From: [Phillips, Brett](#)
To: [Gell, Chris](#); [Taylor, Bob](#)
Cc: [Cilliers, George](#)
Subject: FW: DA201731563 - Request for advice in relation to works being conducted in relation to DA approval... [SEC=UNCLASSIFIED]
Date: Tuesday, 31 July 2018 9:05:40 AM
Attachments: [image003.jpg](#)
[image004.jpg](#)
[DJI_0010.JPG](#)
[DJI_0003.JPG](#)
[SITE-201731563-S144B-PROPOSED-01.pdf](#)
[Letter of Objection Belconnen Section 200 Block 2 - DA201731563 FINAL.PDF](#)

Letter of Objection: DA201731563 S144 Renotification of DA Amendment

Block 2 Section 200 Belconnen

GROUND FLOOR PLAN - CAMERON AVENUE

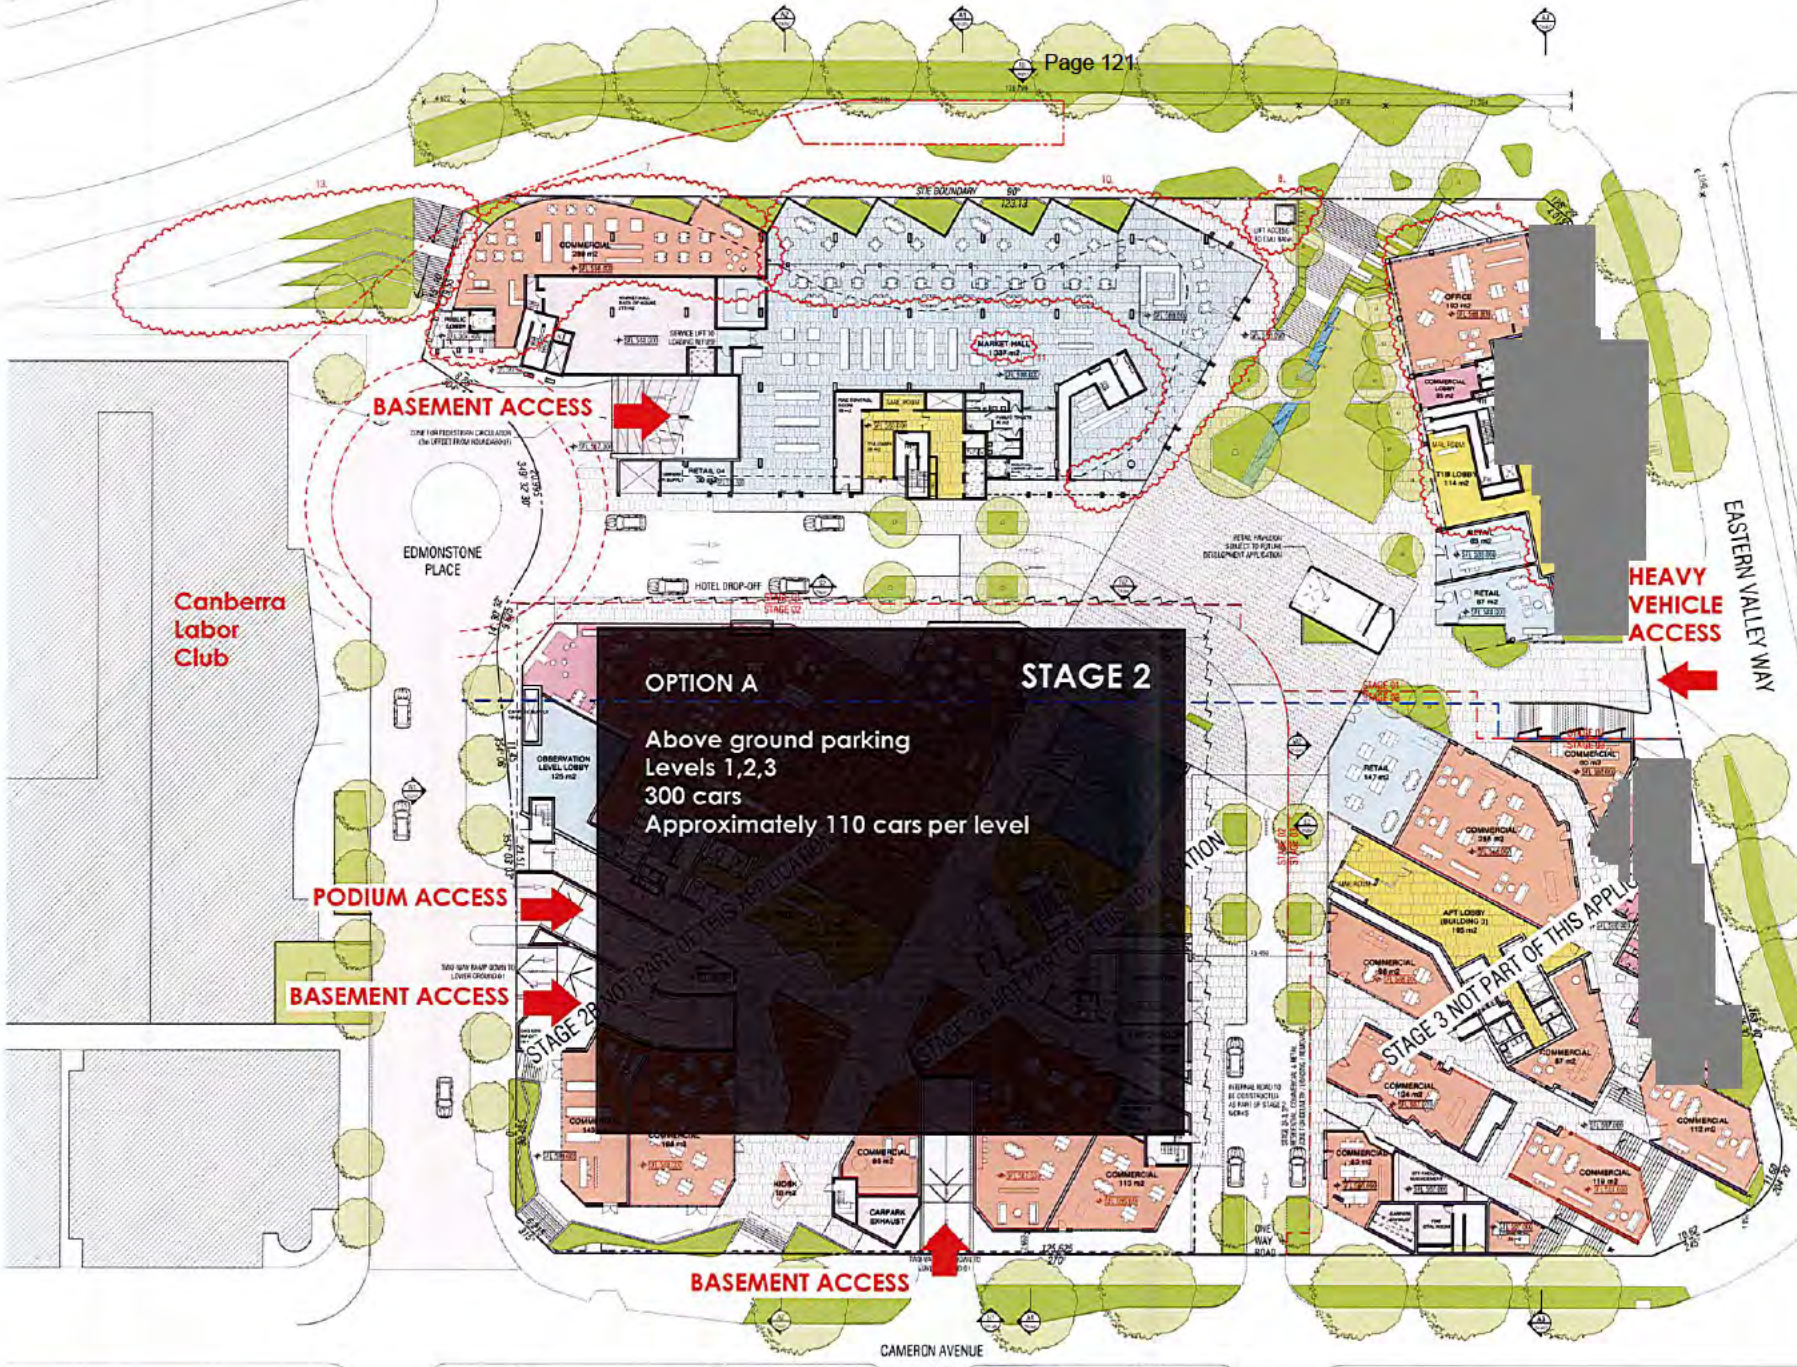
We have reviewed the DA documents (and amendment set as was publicly notified) and specifically considered the Site Plan that was included in the S144 DA amendment for DA201731563 – see attached. We note that the substation structure initially proposed in this location was proposed to have been removed and relocated into the building 1B (See note 12 in attached plan as was notified). From the attached it appears that the only structure in this place would be a stairway – is this correct?

The location of this infrastructure at the Club's front door and at a pinch-point along what will become a major pedestrian connection to the Emu Bank leisure precinct (as per the Master Plan) and the Club's front door is not acceptable for the following reasons.

The proponent is proposing the substation in this location while the Club was advised that development of this land for non-transport functions would not be possible. Unless there is a reversal of policy, a substation in this location will adversely impact on the ability to cater for public transport uses within the Emu Bank road reserve (in the same way that Club related uses would). Again, the location of the substation within the Section 200 boundary would remove all of the concerns listed above and reserve the road reserve for future public transport use. We seek ESPDD's consideration to require the proponent to relocate the substation to an on-site or more suitable location.

As mentioned in your email, the initial DA proposed a substation in this location. In response to objections received through public notification, the Authority requested the substation to be moved and housed within the development. At this time there was not advice from referral entities to suggest the substation would be required to supply more than the development.

Subsequent to advice in responses to the Developers detail design submissions to referral entities, Evoenergy has identified substations required to supply existing and future demands in the network other than for this development.

As a result of the advice, a s197F amendment submission was lodged and approved on 19 July 2018. A copy of the approved plans and Notice of Decision are attached to explain the rationale for not to publicly notify.
